SURFACE VEHICLE INFORMATION REPORT

SAE J2949 DRAFT NOV2010

H-III50M Ankle Update to Eliminate Electrical Signal Noise

Figure 1. Foot Accelerations with the Ankle Design in 1996 NHTSA Regulation

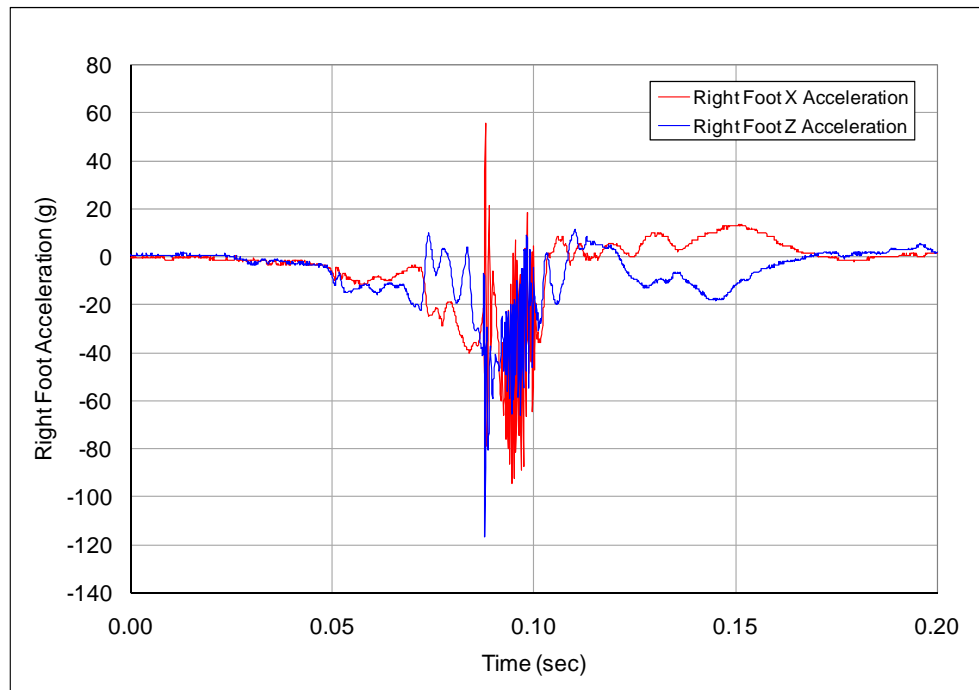
High-speed frontal crash tests conducted by IIHS with HIII50M dummy (with the 1996 version of the ankle design) have shown ringing in the foot accelerometer signals. Postcrash investigation of the dummy revealed the signal ringing was due to metal-to-metal contact between the ankle shaft and the surface just below the ankle bumper. The ringing propagates through the dummy's lower leg, which produces ringing in the tibia and femur load cell signals. The ringing can artificially increase peak injury measures, even after appropriate filtering is applied. In some cases peak injury measure timing from the lower extremity channels occur during a period of ringing in the foot accelerometer channels. In those cases, IIHS had used exclusion zones to limit the reporting of peak lower extremity injury measures to time periods occurring before or after the known time period with signal noise.

IIHS identified the signal noise from foot accelerometer channels in high-speed frontal crash tests. Typical accelerations from the feet are shown in Figure 1.

Figure 2 - Design of Upgraded Ankle Joint

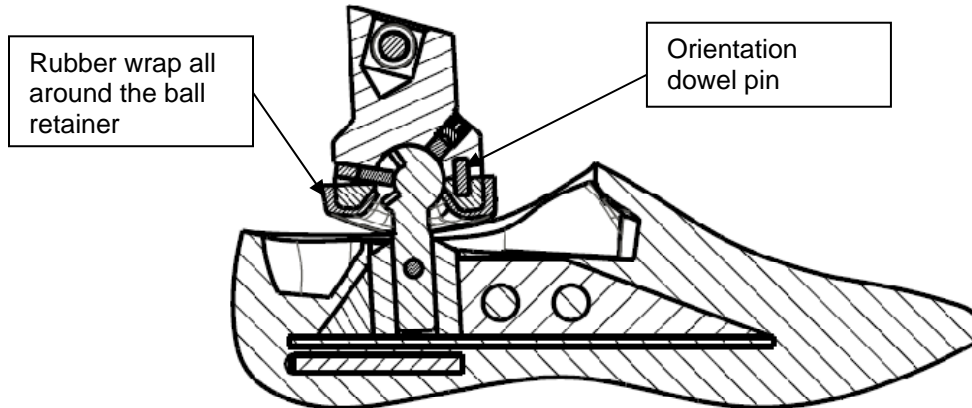
In order to prevent the metal-to-metal contact between the ball shaft and the ankle shell in the Hybrid III ankle joint, the ankle bumper metal insert and the ball retainer have been merged to allow some metal material space to be taken by rubber without changing the overall dimension of the assembly. This change eliminates metal-to-metal contact. A dowel pin/hole feature has been added to prevent the ankle bumper from being installed in the wrong orientation. Figure 2 shows the new design.

Figure 3– Design of the Upgraded Interfaces above and below the Ankle Joint

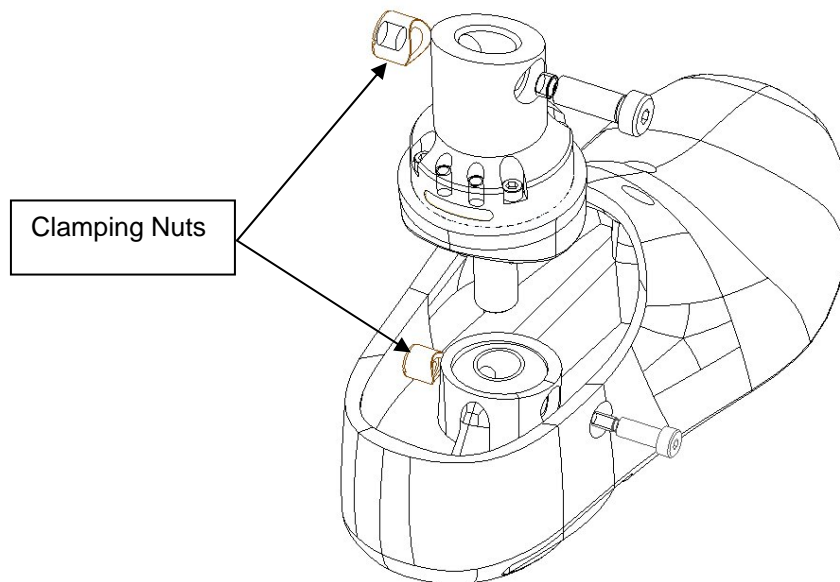
In addition to the modifications mentioned above, the ankle joint interface locations were improved to eliminate slop due to the machining tolerances specified for each part. The new design employs clamping nuts to reduce the slop, which eliminates any play at the two connection interfaces. Figure 3 shows the new ankle design with the clamping nut.

Figure 4, Alignment marks for the clamping nuts

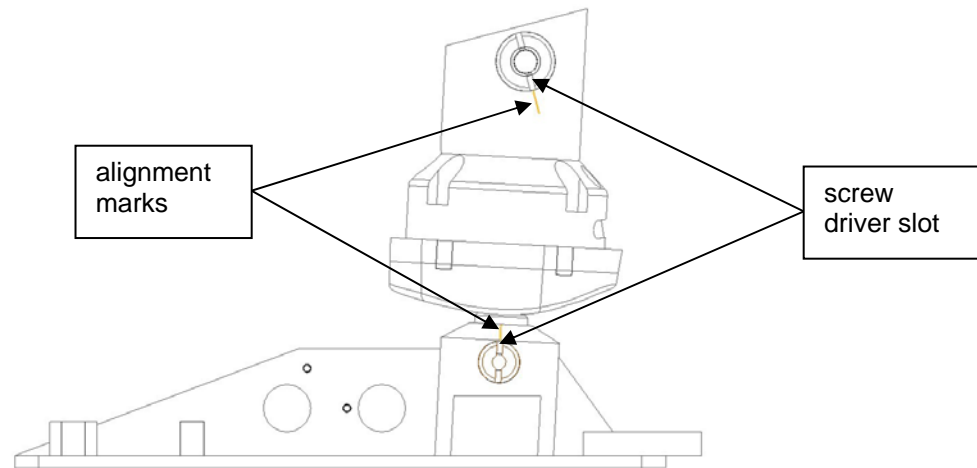
Alignment marks were designed for the ankle shell and the shell of the foot bone to assist the alignment of the clamping nut to the shaft of the tibia bone or the ball shaft, see Figure 4. These alignment marks help to prevent potential damage to the half moon feature of the clamping nut due to the misalignment.

Figure 4a, Left Foot Accelerations with the New Design (Test CF09007)

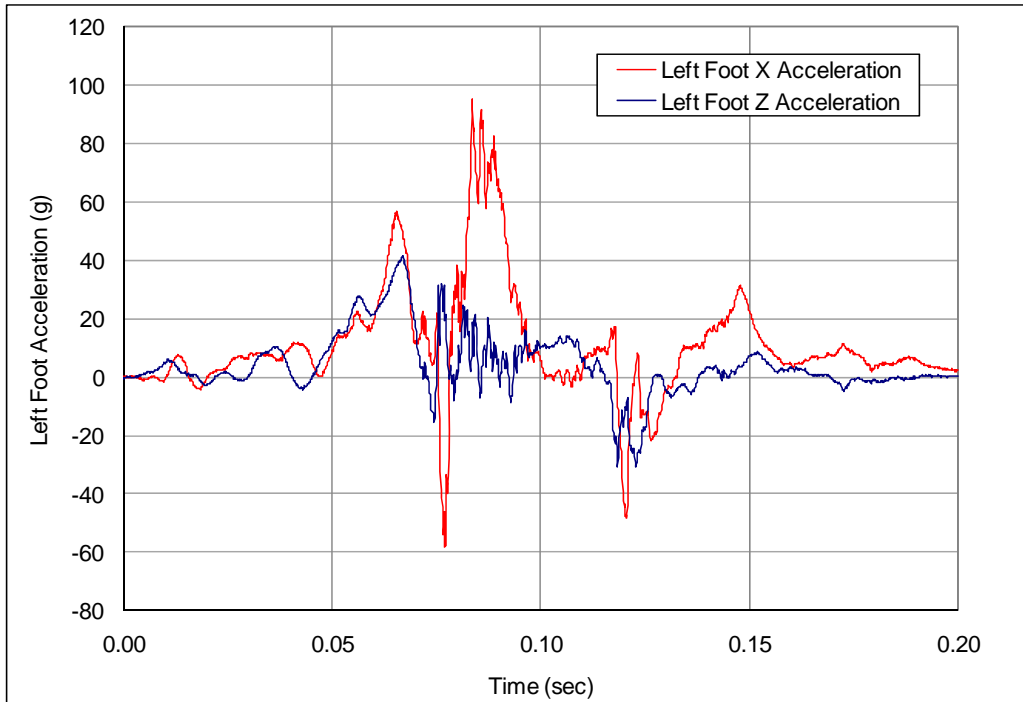
Vehicle crash tests were conducted by IIHS to verify if the new design is able to reduce or eliminate the signal noise issue as described in section 4.1.2. In each IIHS test an instrumented H350M dummy was placed in the driver seating position.
